NEW YORK CITY DEPARTMENT OF CORRECTION
Cynthia Brann, Commissioner

ADDENDUM No. 5 to PIN: 072202001CPD
Powerhouse Boiler Feed Water Treatment System Upgrade

Pursuant to section §3-04 of the Procurement Policy Board (PPB Rules, the Department of Correction (DOC) is issuing Addendum No. 5 to the solicitation for the services referenced above.

Drawing No.:
E202.00

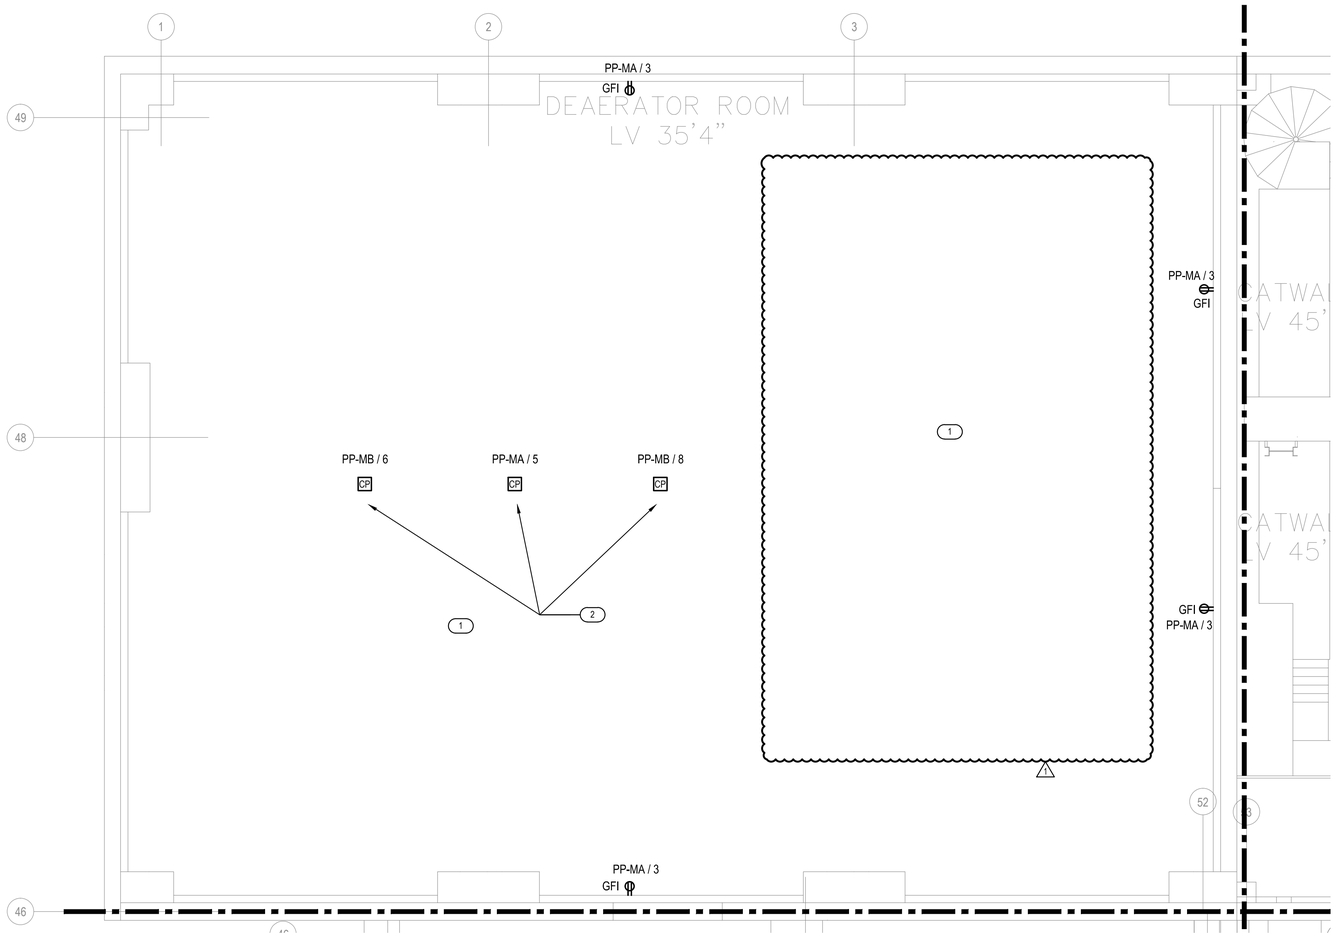
45) E202.00 – Revised RO and CIP locations.

Drawing No.:
E203.00

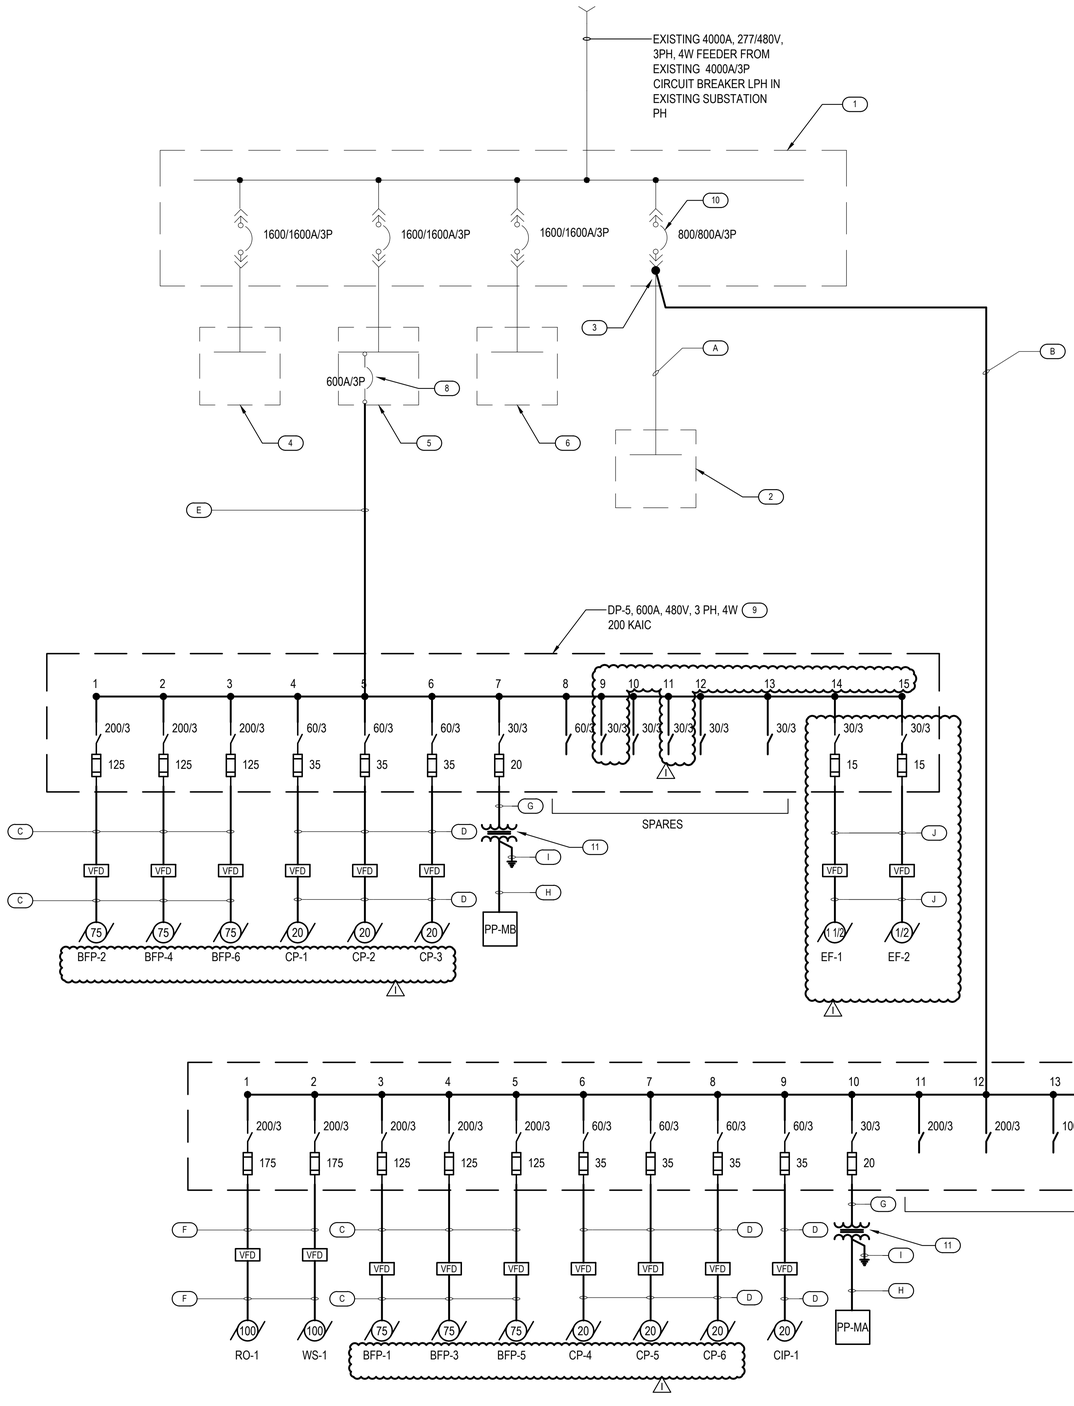
46) E203.00 – Revised RO and CIP location.

Drawing No.: E601.00

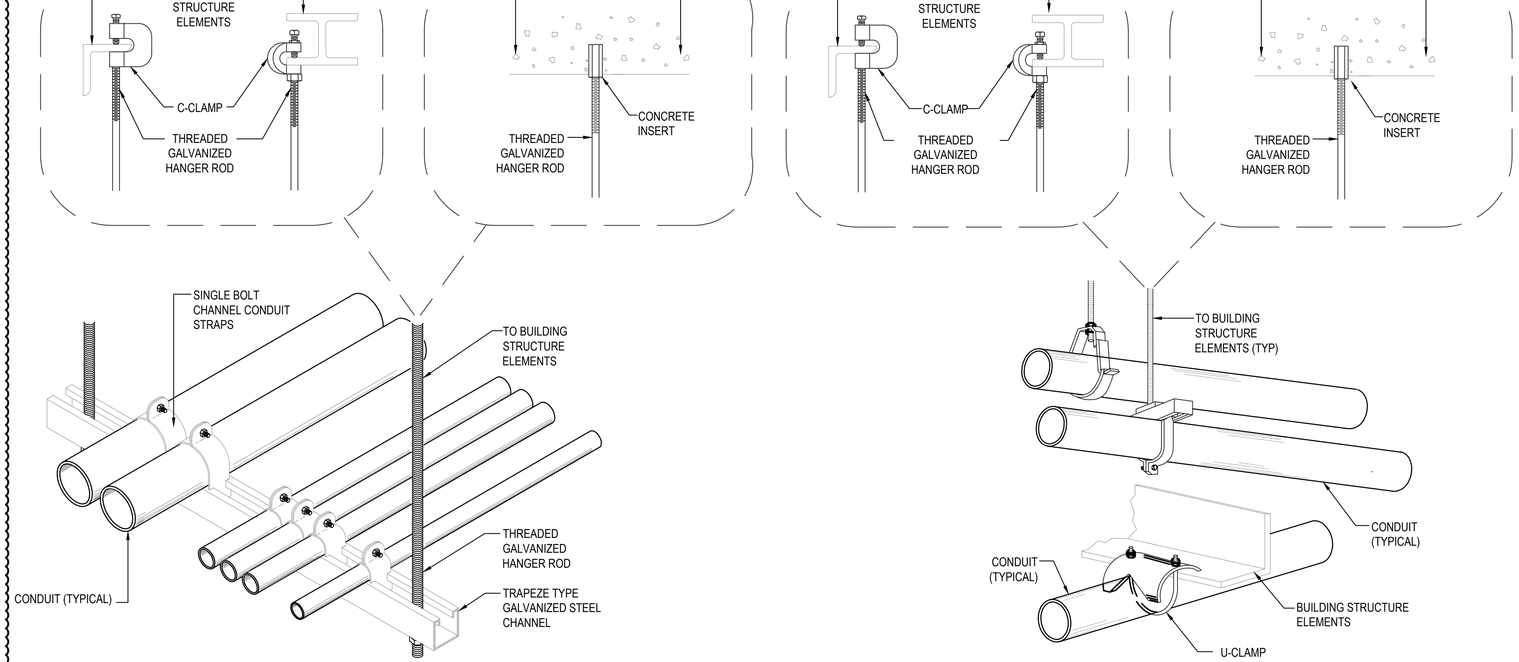
49) E601.00 – Added details.
